## SUBDIVISION REVIEW SHEET

**CASE NO.:** C8-2017-0283.0A**DATE:** December 4, 2018**SUBDIVISION NAME:** Hayah Subdivision, Resubdivision of Lot 3 Block E, Eubank Acres  
Section 1**AREA:** 0.5447 acres**LOT(S):** 2**OWNER/APPLICANT:** Fayez S. Kazi**AGENT:** Civiltude  
(Jessica Milligan)**ADDRESS OF SUBDIVISION:** 11603 Tedford St.**WATERSHED:** Walnut Creek**COUNTY:** Travis**EXISTING ZONING:** SF-1**JURISDICTION:** Full Purpose**PROPOSED LAND USE:** Single-Family

SUBJECT: C8-2017-0283.0A, Hayah Resubdivision, 11603 Tedford St.

**SUBJECT:** C8-2017-0283.0A Hayah Subdivision, Resubdivision of Lot 3 Block E,  
Eubank Acres Section 1

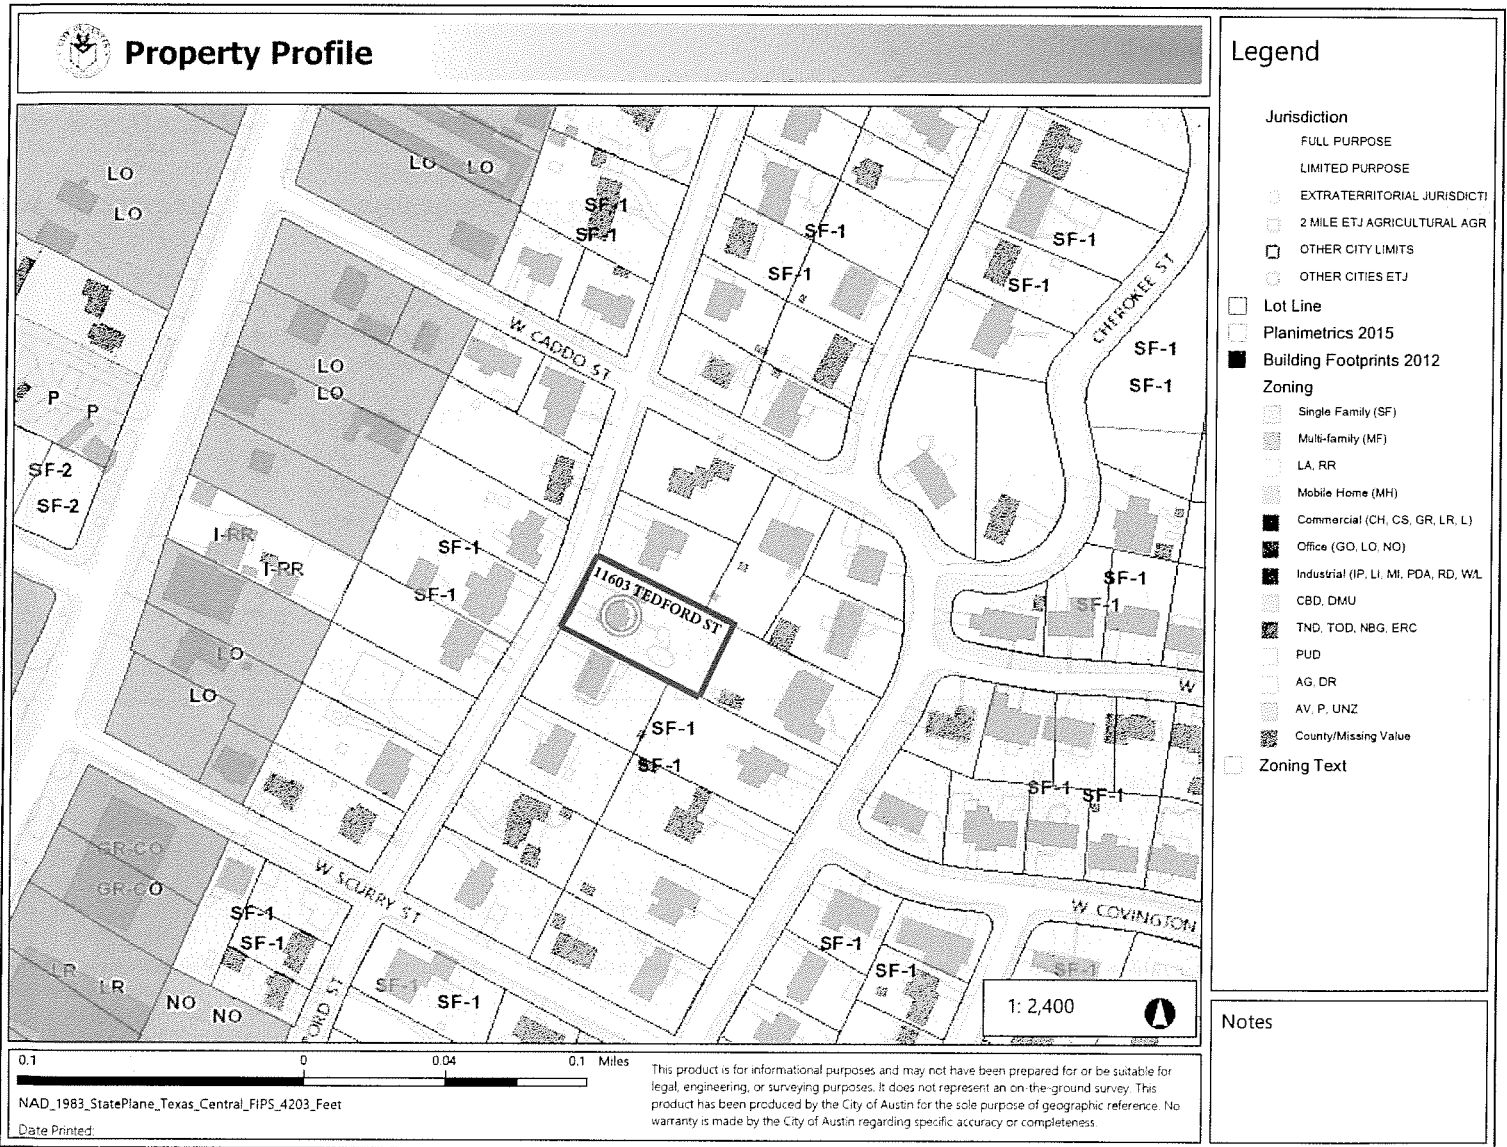
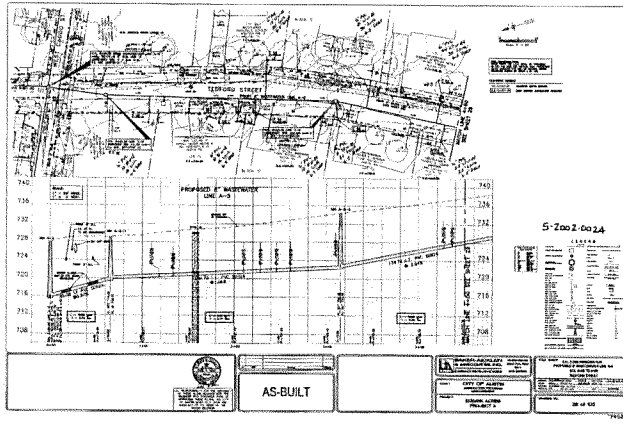
**(iv) is otherwise compatible with the surrounding neighborhood;**

*The property is zoned SF-1 with a minimum lot size of 10,000 square feet. The proposed subdivision will meet the minimum lot size requirement with Lot 3A having a lot size of 11,493 square feet and Lot 3B 12,235 square feet. Additionally, other property within the area has been resubdivided, such as the adjacent property to the north and property located on the intersection of Tedford St. and Caddo St. As well as neighboring blocks having resubdivided lots as demonstrated on property located to the south of this block at Scurry St and Tedford St.*

*The immediate area is zoned SF-1 which is the appropriate zoning for the proposed use. See the attached neighborhood exhibit which generally shows the development pattern in the immediate vicinity.*

Based upon review of these criteria, staff **recommends** the variance request to develop a flag lot as a part of this resubdivision request.
